Application by Anglian Water Limited for an Order Granting Development Consent for the Cambridge Waste Water Treatment Plant Relocation project

The Examining Authority's written questions and requests for information (ExQ1)

Issued on 24 October 2023

2.14 CCC Emerging local plan and draft NECAAP

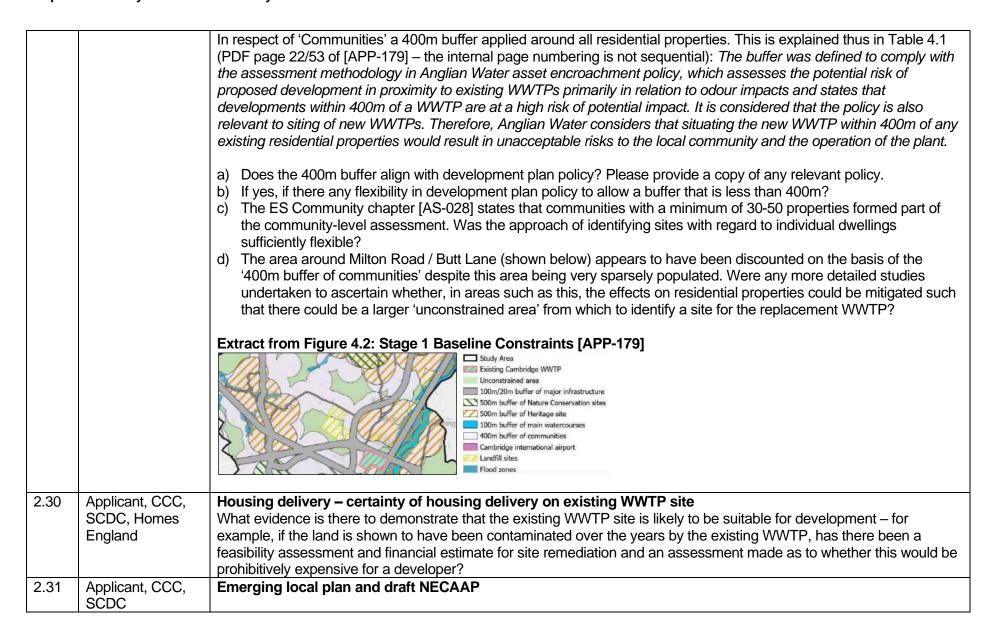
CCC's RR [RR-002] states that: 28. The City Council recognises that one of the issues the ExA may need to explore is that of reasonable alternatives to the relocation of the existing CWWTP and what the City Council's position is in light of the above and the clear contribution the DCO project makes towards achieving the objectives currently contained within the emerging joint GCLP. and that 29. The evidence base supporting the emerging GCLP is clear. This concludes, of all the options considered, the NEC site (which includes the existing CWWTP site as noted above), is the most sustainable location for development in the area. a) Please provide a copy of the evidence base / Sustainability Appraisal that concludes that, of all of the options considered, the NEC site is the most sustainable location; b) Did the assessment of sustainability take account of the release of Green Belt land to facilitate development of the NEC site when it assessed the relative sustainability of growth options? If not, clarify the reason for this; c) Has an option been considered where the existing WWTP remains in situ and other parts of NEC are redeveloped? Has this possibility been independently assessed by / on behalf of the Council and consulted on; d) Which alternatives to NEC were considered and discounted; e) RR [RR-200] mentions potential for housing development at Impington and Histon and at Cambridge City Airport instead of using the existing WWTP site – please clarify whether these sites have been considered for future housing development? f) Has an option of denser development at other proposed allocations / on a reduced-size NEC been explored as an alternative to the currently proposed extent of NEC?
